MOBILE PRESS REGISTER SUBDIVISION, **FIRST ADDITION**

APPLICATION NUMBER 17 DATE June 5, 2003
APPLICANT Mobile Press Register Subdivision, First Addition
REQUEST Subdivision

MOBILE PRESS REGISTER SUBDIVISION, FIRST ADDITION

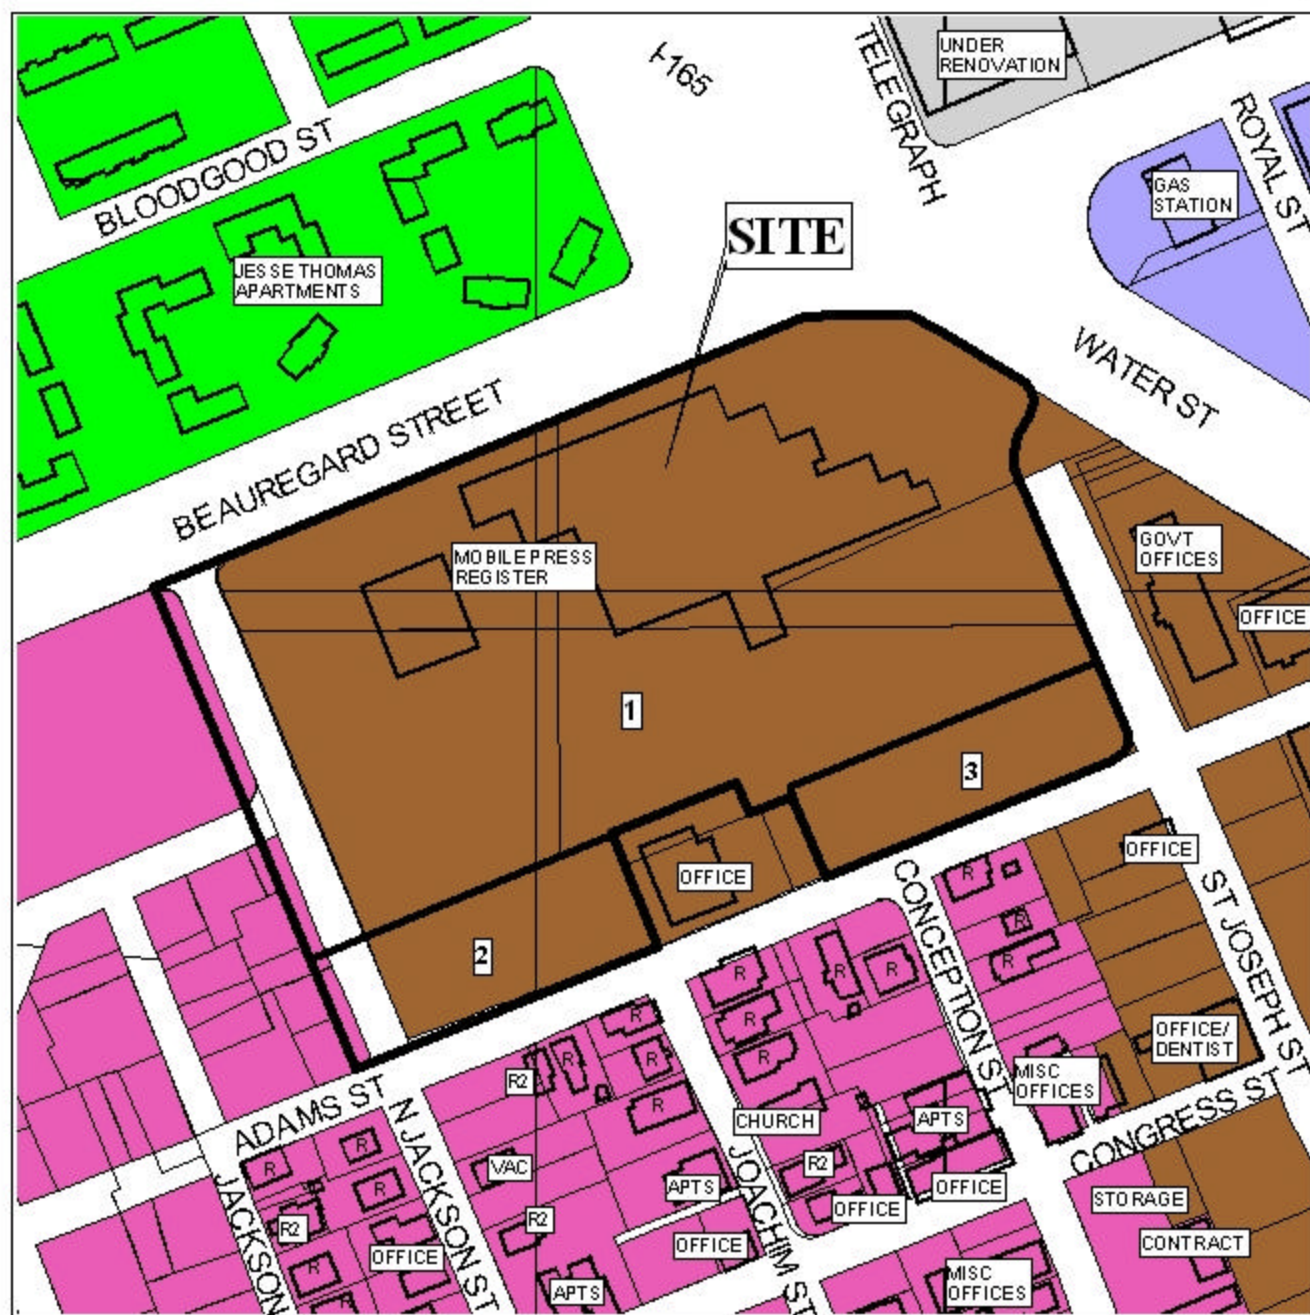
The plat illustrates the proposed 3 lot, 14.3± acre subdivision which is located in an area bordered by Beauregard Street on the North; Water Street and St. Joseph Street on the East; Adams Street on the South; and the West right-of-way line of Jackson Street (vacated) on the West; less and except the North side of Adams Street 407'± West of St. Joseph Street, extending to the West 220'±. The site is served by city water and sanitary facilities.

The purpose of this application is to include a vacated right-of-way (Jackson Street) into a legal three-lot subdivision.

Since this development is at the intersection of two major streets access management is a concern. Prior to the vacation of Jackson Street, three curb cuts were located on the portion of Jackson Street. Therefore, a note should be placed on the final plat limiting the development to two curb cuts, one curb cut to Beauregard Street and one curb cut to Saint Joseph Street, with the size, location and design to be approved by Traffic Engineering. Moreover, the Commission granted PUD approval for shared access and parking between the three lots at the April 7, 2000 meeting.

The plat meets the minimum requirements of the Subdivision Regulations and is recommended for Tentative Approval subject to the following condition: 1) the placement of a note on the final plat stating the development is limited to two curb cuts, one curb cut to Beauregard Street and one curb cut to Saint Joseph Street, with the size, location and design to be approved by Traffic Engineering.
